Reading Borough Council Wensley Road : New Build & Estate Improvements Phase 1

Post-planning Design Changes Report

RBC-WLR-HTA-A_XX_XX_RP_1790

March 2022

3.1 Block B
GA Plan

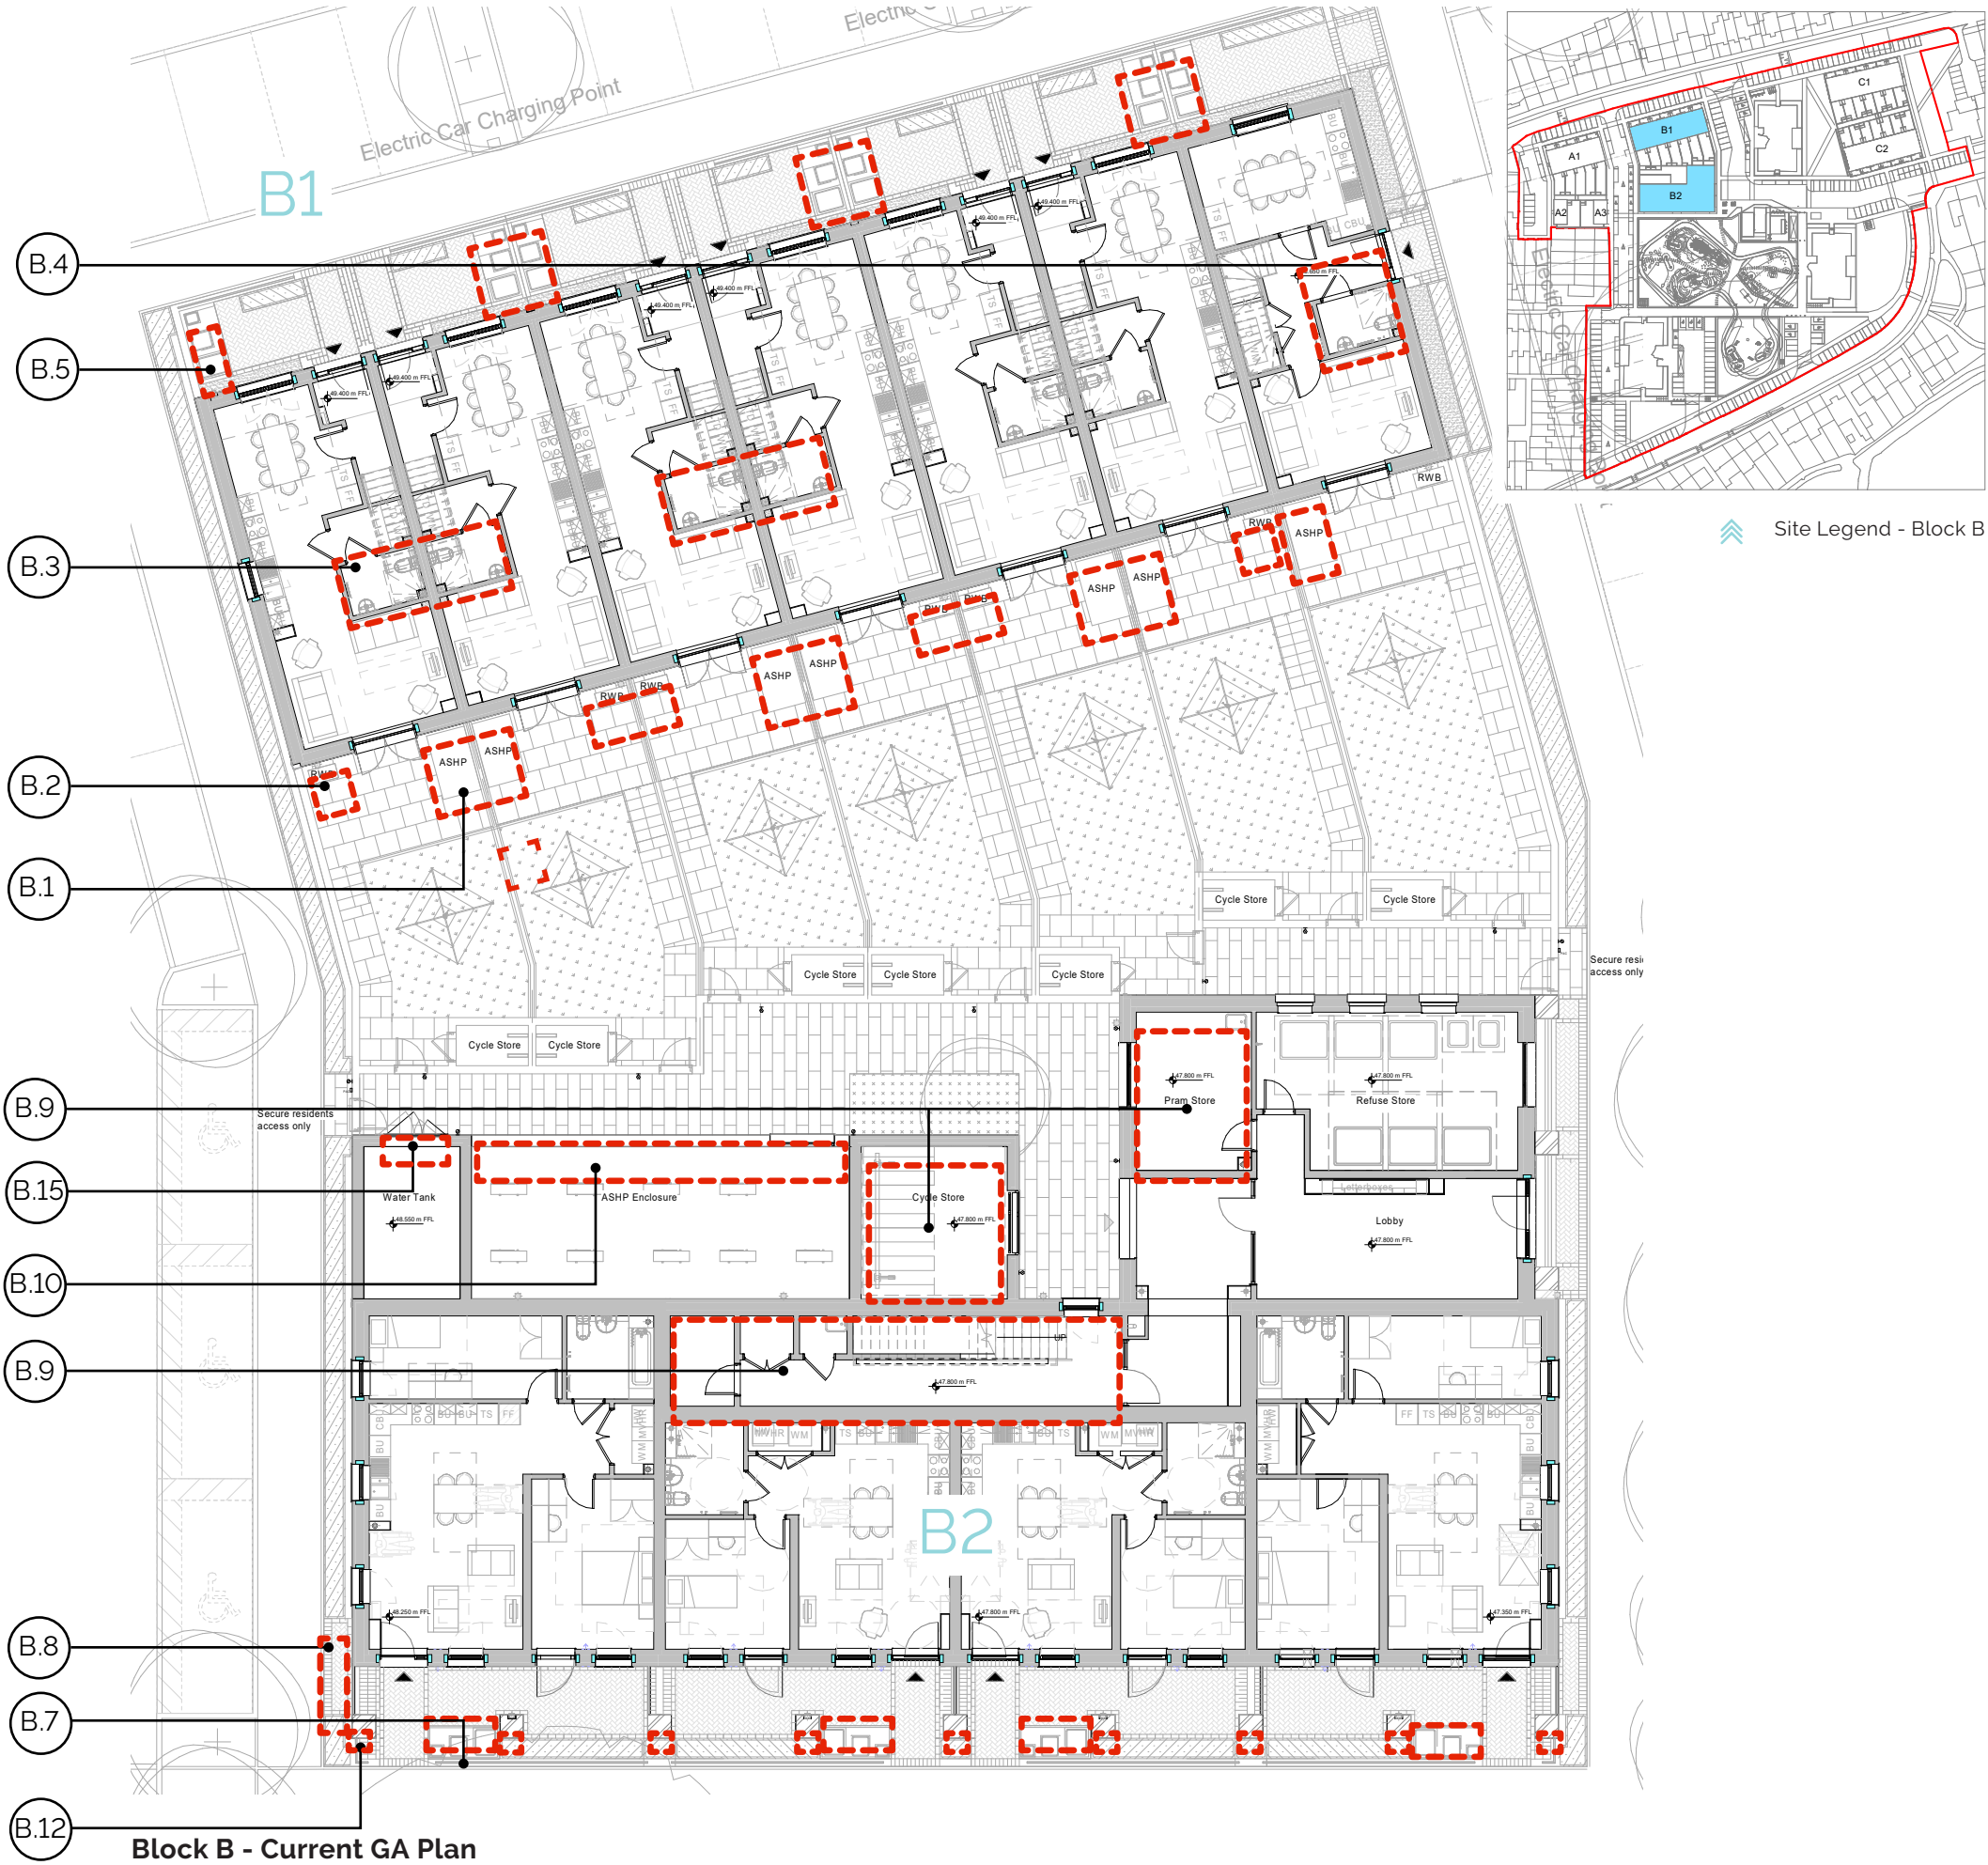
B.1	ASHP moved within the rear garden, adjacent to the houses.
B.2	Water butts and additional rain water pipes added.
B.3	Ground floor WC increased to meet M(4)2 requirements.
B.4	Ground floor WC and entrance door flipped to resolve internal layout.
B.5	Material of individual refuse stores changed from brick to perforated metal.
B.6	Step in ground floor FFL increased from 450mm to 750mm
B.7	Location of individual refuse store to ground floor flats amended.
B.8	Refuse presentation points added.
B.9	Communal Cycle store relocated to provide pram store internally.
B.10	Communal ASHP enclosure changed from brick to acoustic louvres.
B.11	Communal staircore reconfigured in accordance with AD Part B , with window locations and sizes amended to suit.
B.12	Columns to apartment block increased from 440mm to 625mm .
B.13	Change to third floor balcony, east and west elevation from metal railings to brick.
B.14	Juliette balconies replaced with window and brick panel below.

B.15	Access to water tank relocated to rear garden access route.
B.16	Obscured bedroom windows omitted. Windows added to refuse stores.
B.17	Minor Amendments to parapet and ridge heights.
B.18	Satellite dishes added.
B.19	PV panels removed from B2 east roof due to overshadowing

Block B1 South Elevation - Planning

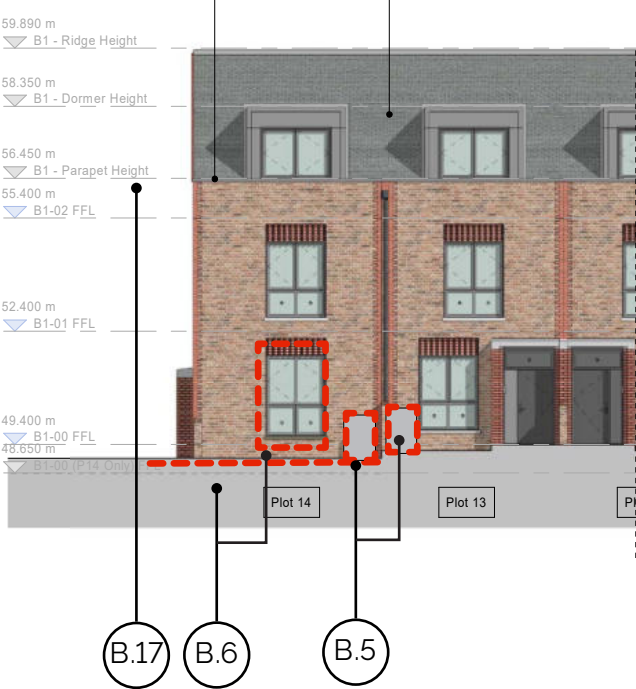
B.1	ASHP moved within the rear garden, adjacent to the houses.
B.2	Water butts and additional rain water pipes added.
B.3	Ground floor WC increased to meet M(4)2 requirements.
B.4	Ground floor WC and entrance door flipped to resolve internal layout.
B.5	Material of individual refuse stores changed from brick to perforated metal.
B.6	Step in ground floor FFL increased from 450mm to 750mm
B.7	Location of individual refuse store to ground floor flats amended.
B.8	Refuse presentation points added.
B.9	Communal Cycle store relocated to provide pram store internally.
B.10	Communal ASHP enclosure changed from brick to acoustic louvres.
B.11	Communal staircore reconfigured in accordance with AD Part B , with window locations and sizes amended to suit.
B.12	Columns to apartment block increased from 440mm to 625mm .
B.13	Change to third floor balcony, east and west elevation from metal railings to brick.
B.14	Juliette balconies replaced with window and brick panel below.

B.15	Access to water tank relocated to rear garden access route.
B.16	Obscured bedroom windows omitted. Windows added to refuse stores.
B.17	Minor Amendments to parapet and ridge heights.
B.18	Satellite dishes added.
B.19	PV panels removed from B2 east roof due to overshadowing

Block B1 East Elevation - Planning

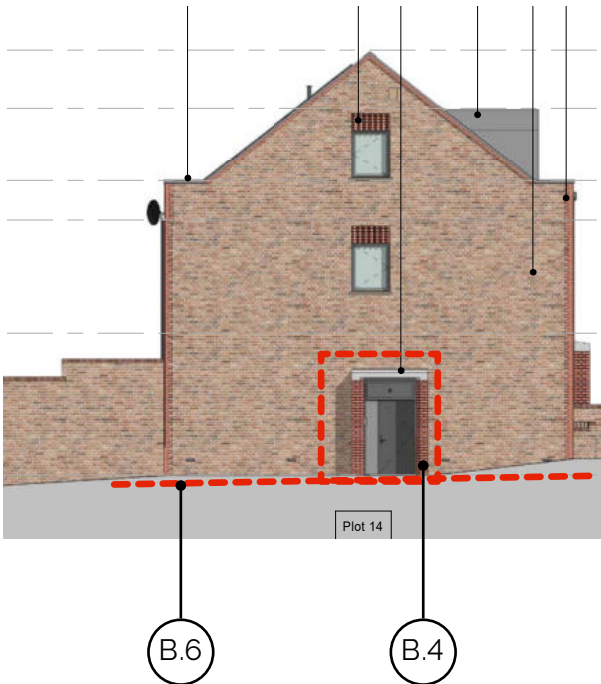
B.1	ASHP moved within the rear garden, adjacent to the houses.
B.2	Water butts and additional rain water pipes added.
B.3	Ground floor WC increased to meet M(4)2 requirements.
B.4	Ground floor WC and entrance door flipped to resolve internal layout.
B.5	Material of individual refuse stores changed from brick to perforated metal.
B.6	Step in ground floor FFL increased from 450mm to 750mm
B.7	Location of individual refuse store to ground floor flats amended.
B.8	Refuse presentation points added.
B.9	Communal Cycle store relocated to provide pram store internally.
B.10	Communal ASHP enclosure changed from brick to acoustic louvres.
B.11	Communal staircore reconfigured in accordance with AD Part B , with window locations and sizes amended to suit.
B.12	Columns to apartment block increased from 440mm to 625mm .
B.13	Change to third floor balcony, east and west elevation from metal railings to brick.
B.14	Juliette balconies replaced with window and brick panel below.

B.15	Access to water tank relocated to rear garden access route.
B.16	Obscured bedroom windows omitted. Windows added to refuse stores.
B.17	Minor Amendments to parapet and ridge heights.
B.18	Satellite dishes added.
B.19	PV panels removed from B2 east roof due to overshadowing

3.2 Block B GA Elevation

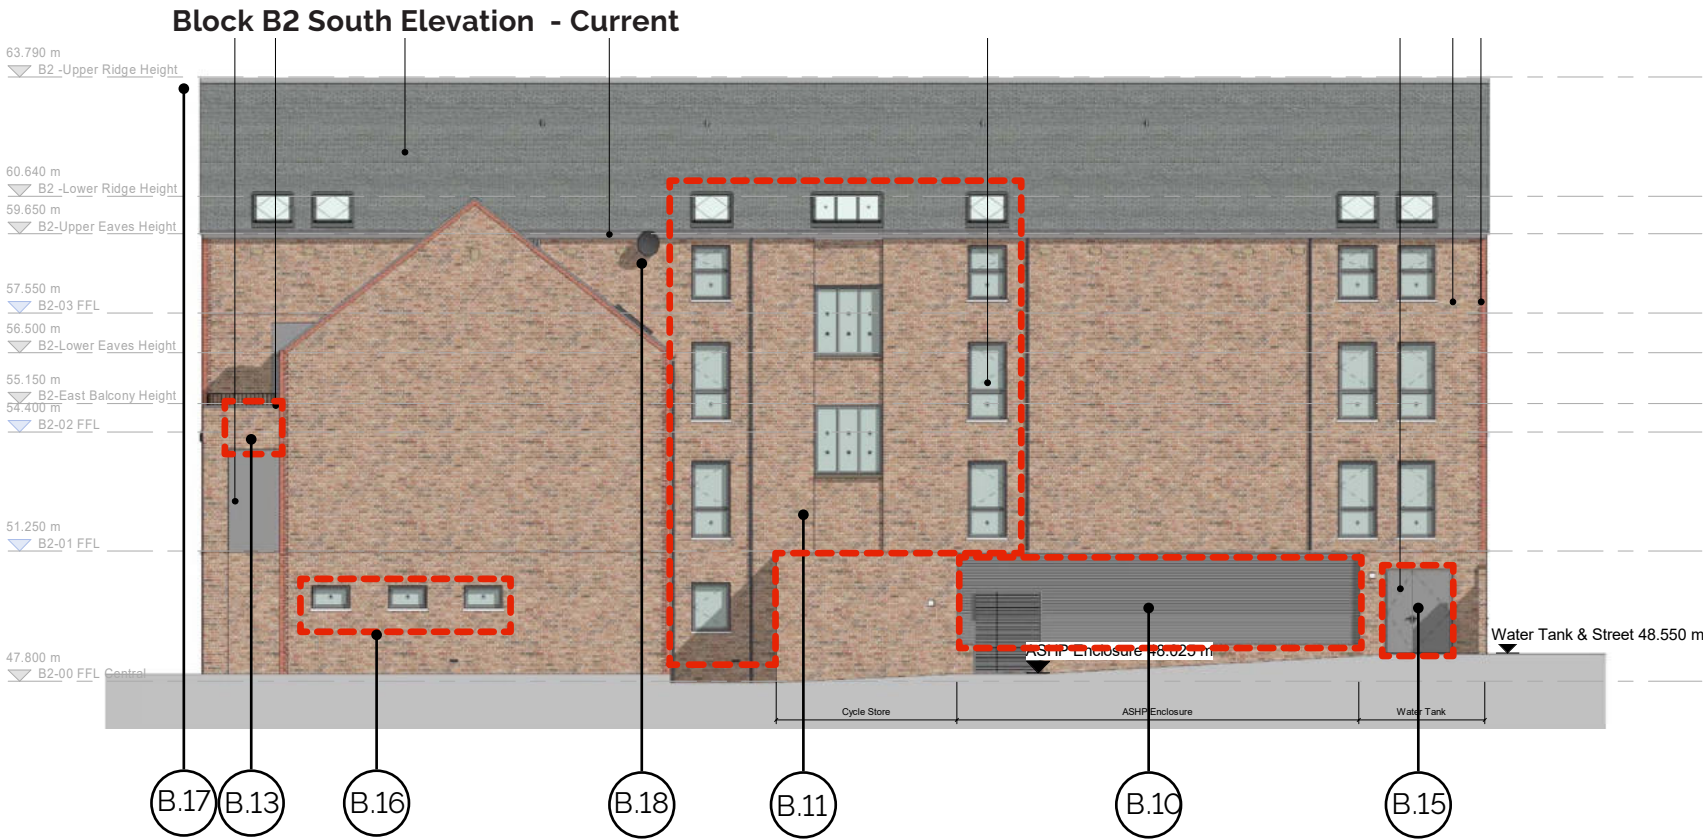
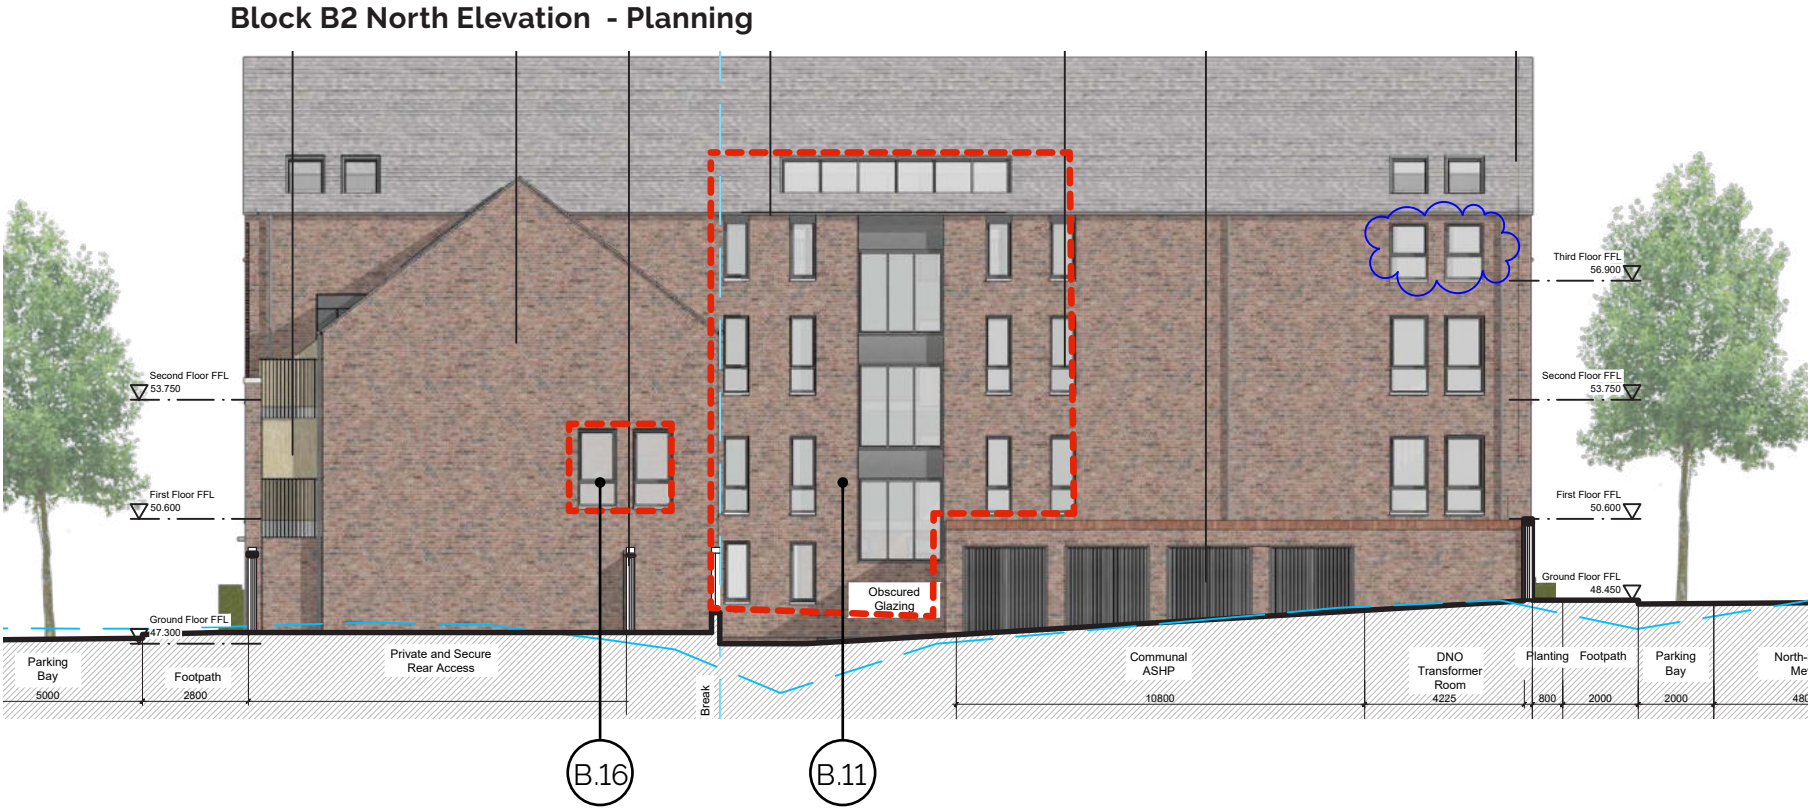
B.1	ASHP moved within the rear garden, adjacent to the houses.
B.2	Water butts and additional rain water pipes added.
B.3	Ground floor WC increased to meet M(4)2 requirements.
B.4	Ground floor WC and entrance door flipped to resolve internal layout.
B.5	Material of individual refuse stores changed from brick to perforated metal.
B.6	Step in ground floor FFL increased from 450mm to 750mm
B.7	Location of individual refuse store to ground floor flats amended.
B.8	Refuse presentation points added.
B.9	Communal Cycle store relocated to provide pram store internally.
B.10	Communal ASHP enclosure changed from brick to acoustic louvres.
B.11	Communal staircore reconfigured in accordance with AD Part B , with window locations and sizes amended to suit.
B.12	Columns to apartment block increased from 440mm to 625mm .
B.13	Change to third floor balcony, east and west elevation from metal railings to brick.
B.14	Juliette balconies replaced with window and brick panel below.

B.15	Access to water tank relocated to rear garden access route.
B.16	Obscured bedroom windows omitted. Windows added to refuse stores.
B.17	Minor Amendments to parapet and ridge heights.
B.18	Satellite dishes added.
B.19	PV panels removed from B2 east roof due to overshadowing
